MILLSTONE NUCLEAR POWER STATION, UNIT NO. 3

AMENDMENT TO FACILITY OPERATING LICENSE

Amendment No. 57
License No. NPF-49

ATTACHMENT TO LICENSE AMENDMENT NO. 67

FIGURE 3.1-2

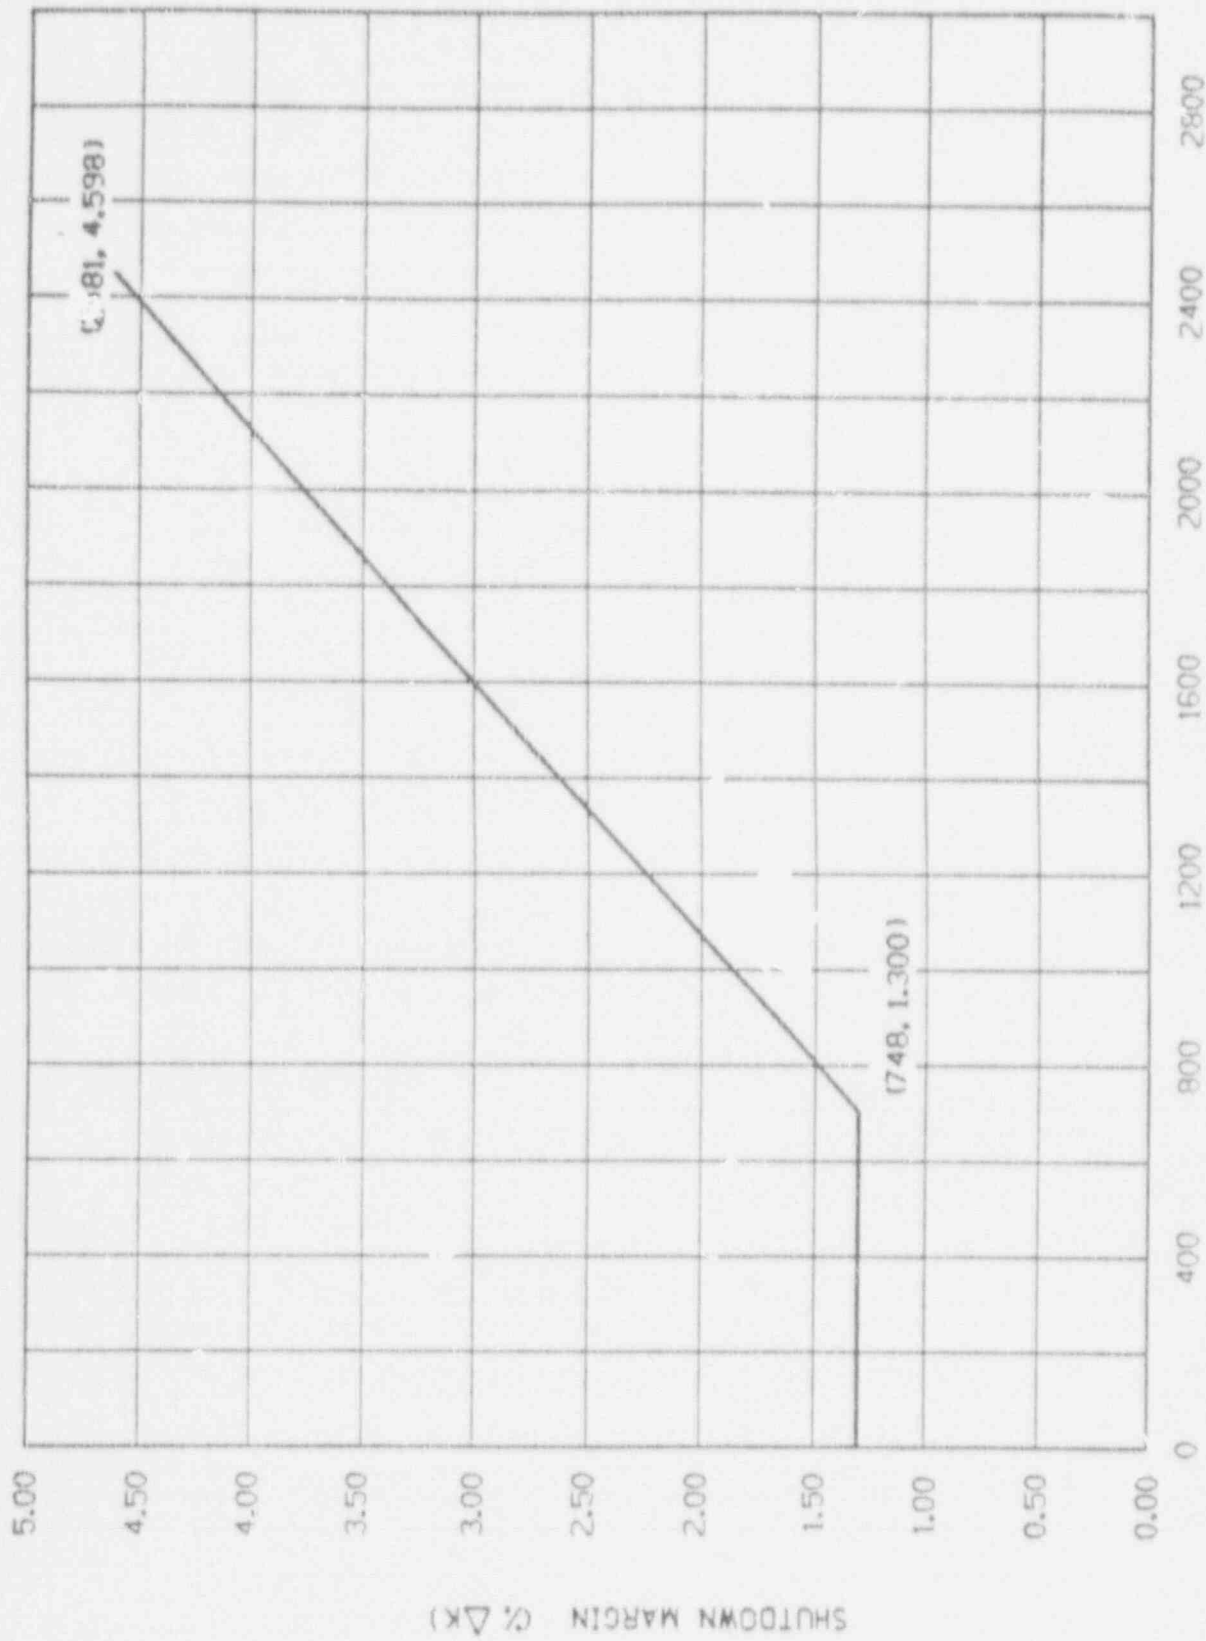
Replace the following pages of the Appendix A Technical Specifications with the enclosed pages. The revised pages are identified by amendment number and contain vertical lines indicating the areas of change.

REQUIRED SHUTDOWN MARGIN FOR MODE 3 WITH THREE LOOPS IN OPERATION
